Certificate of Appropriateness Case Report

Filing Date: December 31, 2009
Case No.: **2009.1183A**
Project Address: **901 VALENCIA STREET**
Historic Landmark: Liberty-Hill Historic District
Zoning: Valencia Street Neighborhood Commercial District
50-X Height and Bulk District
Block/Lot: 3609/042
Applicant: Deilly Echeverri
Sinbordes Design
1000 Texas Street, Suite H
Fairfield, CA 94533
Staff Contact Pilar LaValley - (415) 575-9084
pilar.lavalley@sfgov.org
Reviewed By Timothy Frye - (415) 575-6822
tim.frye@sfgov.org

SHEET TITLE: **NEW FRONT ELEVATION**

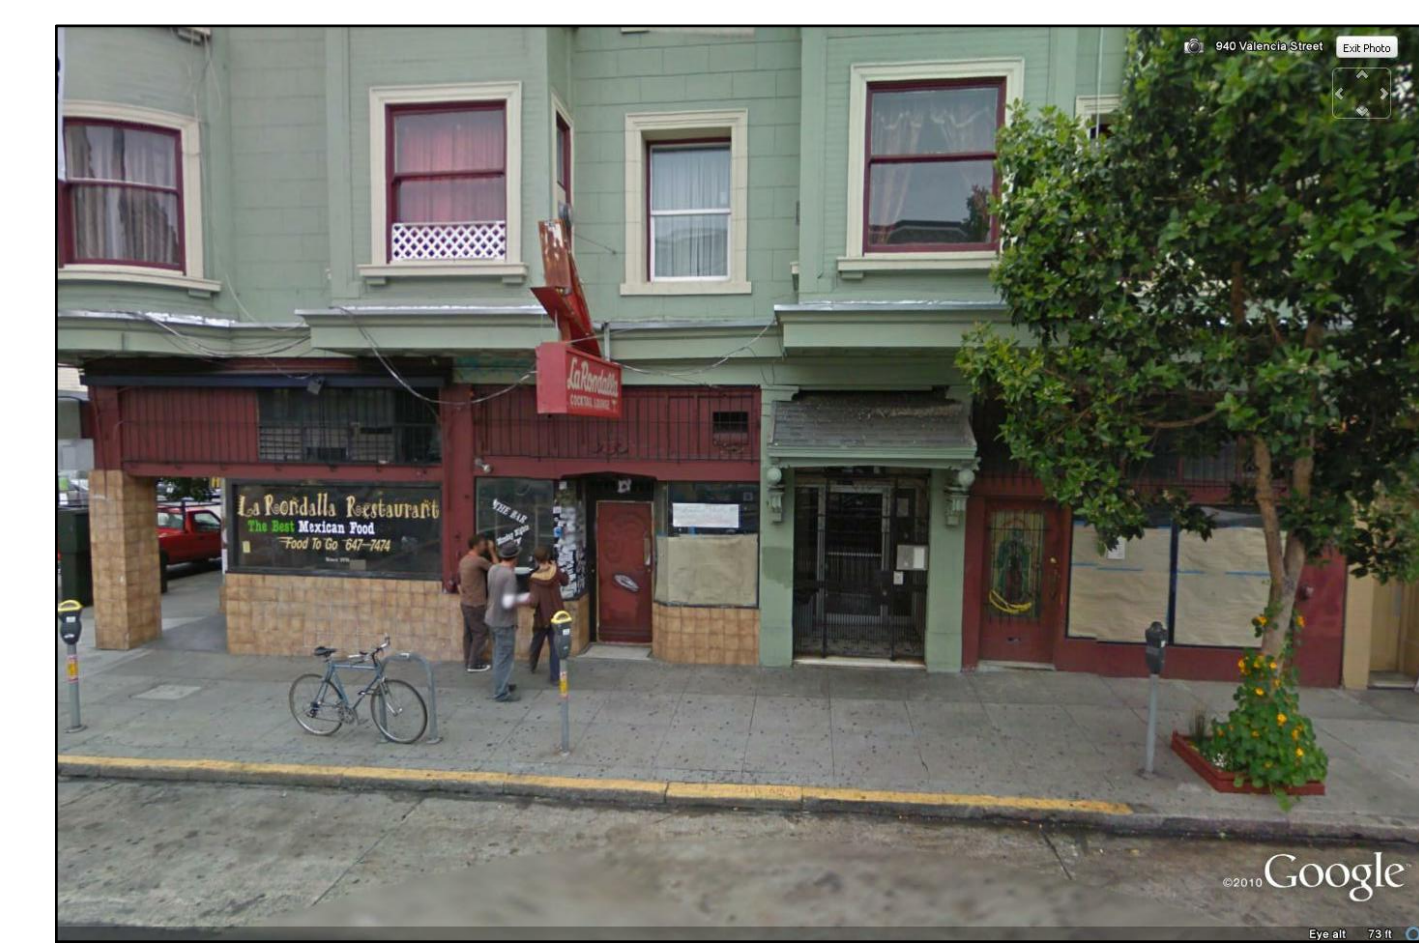
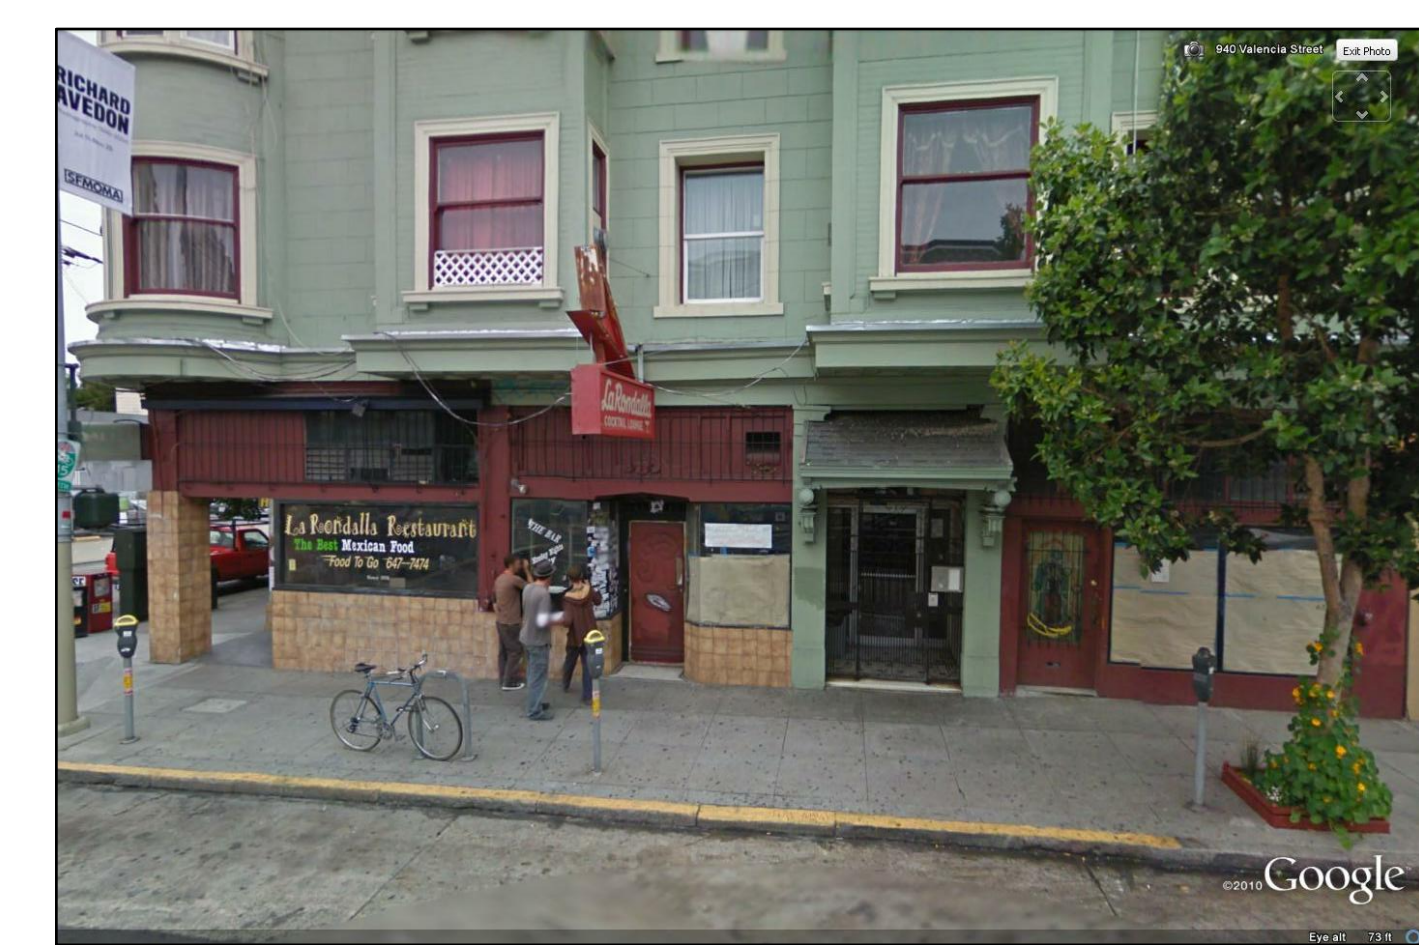
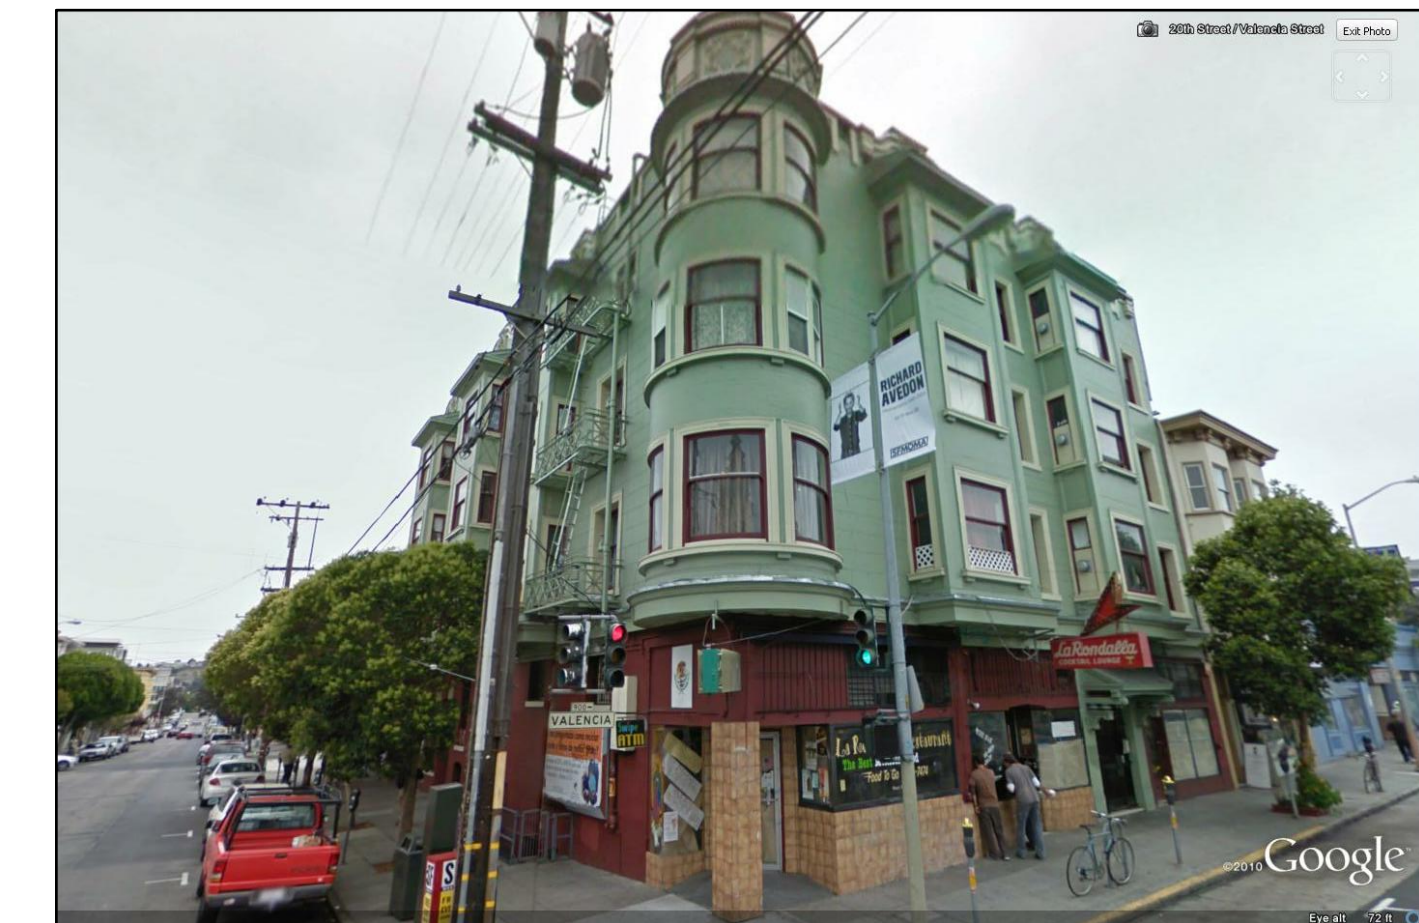
The storefront and transom windows in the center bay facing Valencia Street were removed without benefit of a Building Permit or Certificate of Appropriateness. Photographs indicate that the transom windows removed from this location may have been original though the storefront was not. The current proposal seeks to legalize this work with installation of a compatible new storefront and transom.

Storefront System: The painted wood-frame storefront system, resting on a low bulkhead wall clad in glazed ceramic tile, with recessed angled entrances and a corner entrance, reflects the materials, openness, and configuration typical of storefronts in the district. The proposal will appropriately enlarge the storefront windows by lowering the bulkhead wall at the corner entrance and adjacent window bay. The custom wood storefront will have simple mullions and will appear as a contemporary interpretation of historic storefronts found within the District. The existing (likely original) corner entrance will be retained while the recessed angled entrances and tile clad storefront bulkhead are features typical of the district. New doors will be wood frame with center fixed lights. Staff believes that the proposed storefront system is a contemporary version of such features that is consistent and compatible with the character-defining features of the building and district.

Transom: Historic photographs depict divided light transom windows over each ground floor storefront bay including the corner entrance. At the corner entrance, extant wood or metal transom sash have been partially infilled with glass louvers and/or painted over. The proposal will remove all extant transom sash and install new wood transoms in a configuration, size, and appearance that is compatible with the building and District. Staff believes that the proposed transom is a contemporary version of such features and is consistent and compatible with the character-defining features of the building and district.

1. As part of the Building Permit, dimensioned elevations, details, and sections showing all exterior profiles and dimensions for new painted, wood-frame storefront and transoms will be forwarded for review and approval by Planning Department Preservation Staff prior to installation and approval of the permit application by the Planning Department. Framing and mullion profiles shall be consistent with character-defining features of the district.
2. As part of the Building Permit, product specifications and samples of the glazed ceramic tile, and product specifications and color palette for attachment mortar, proposed for the new bulkhead wall will be submitted for review and approval by Planning Department Preservation staff.
3. Any proposed new signs and/or awnings shall require review under a separate Certificate of Appropriateness case.
